Reference: #N112650

**RE: SYDNEY OLYMPIC PARK MASTERPLAN 2030 (2016 REVIEW)
ASSESSMENT OF TRAFFIC AND TRANSPORT OUTCOMES**

GTA Consultants (GTA) has reviewed the Sydney Olympic Park Master Plan 2030 (2016 Review) documentation with respect to traffic and transport outcomes for the Central Precinct and Sydney Olympic Park generally. The key recommendations are summarised below.

Figure 1: Key Transport Network Changes in Sydney Olympic Park Master Plan 2030 (2016 Review)

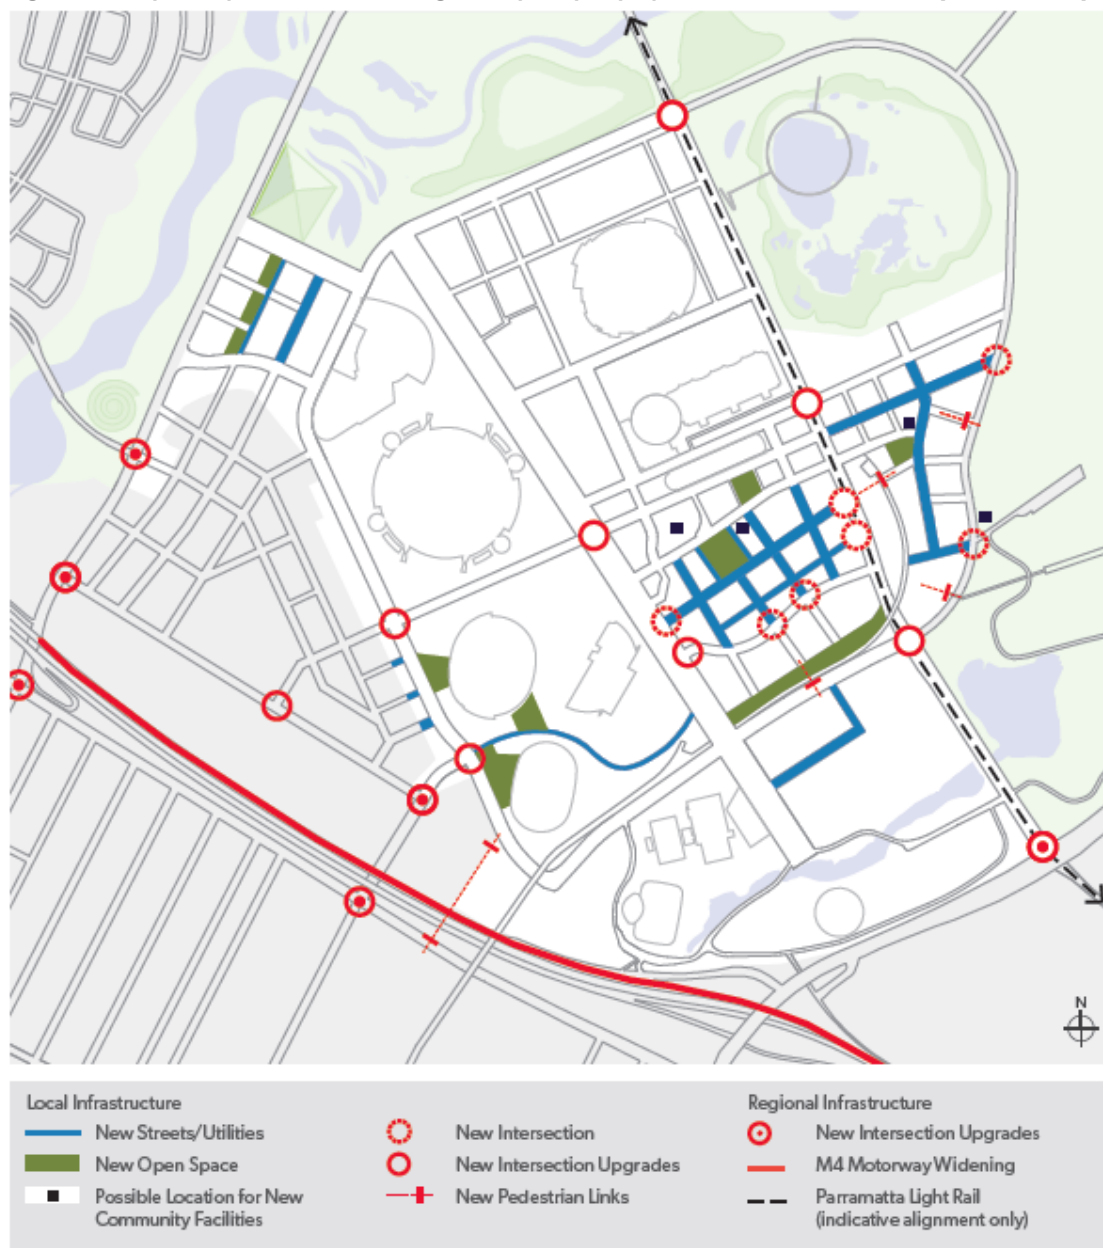
While the MP Review notes that the *"recommended upgrades to the impacted road networks are fundamentally unchanged"*, it also notes that *"it is likely that more significant upgrades (than those nominated in the Baseline Transport Strategy) to gateway intersections and other key intersections providing access to and from SOP will be required due to the increased development proposed in surrounding areas"*.

At this stage, the extent of these upgrades are unknown, as they are under investigation as part of the *Olympic Peninsula Regional Transport Infrastructure Investigations* by Roads and Maritime Services. Consultation with landowners and transport stakeholders would assist in understanding the timing and traffic generation of proposed developments and the associated timing of external road network upgrades.

While the intersection upgrades on the key existing access routes to Sydney Olympic Park are identified, and WestConnex works referenced, there is no further information in relation to any specific strategic access point opportunities. It would be valuable for the *Olympic Peninsula Regional Transport Infrastructure Investigations* to consider regional connectivity and upgrades, such that potential solutions are available and can be planned for.

Figure 3.9 Vehicular Access Plan

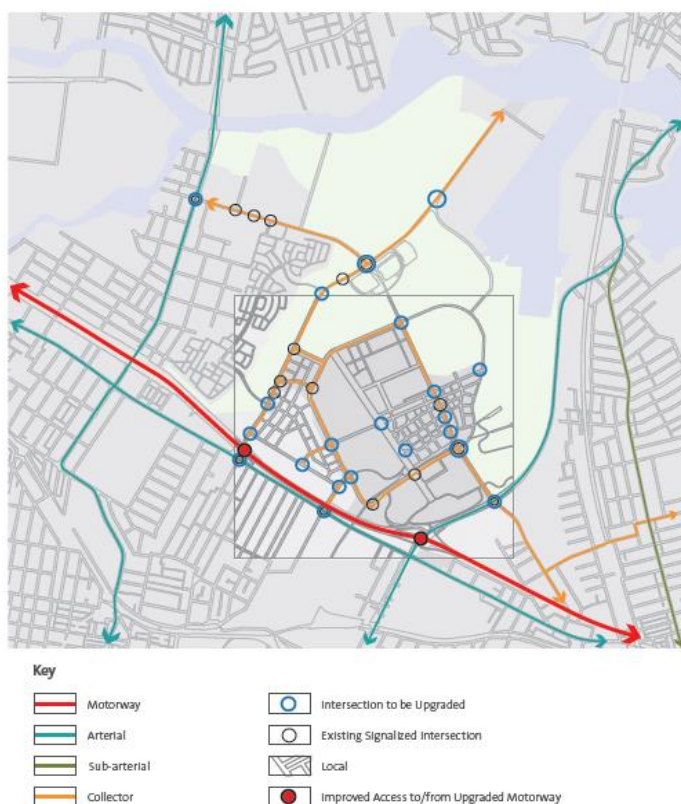
The MP Review and the DP&E planning report identify slightly different intersection works around the Central Precinct as shown in the extracts below. For example, and specifically related to the Central Precinct, the Australia Ave/ Figtree Drive intersection is identified for upgrade in the Vehicular Access Plan, but not elsewhere. The T&T Review no longer recommends that this intersection is signalised, but references a section of the document that does not exist for further details (this is the same for details of other upgrade works).

As previously noted, it is anticipated that further detailed network analysis and modelling (including consideration of Parramatta Light Rail impacts) will be required to adequately finalise the scope of road network upgrades required to support the master plan. Ideally, a suitable level of flexibility would be applied to the ICF in particular, with more detailed studies commenced upon finalisation of the MP Review to provide greater certainty.
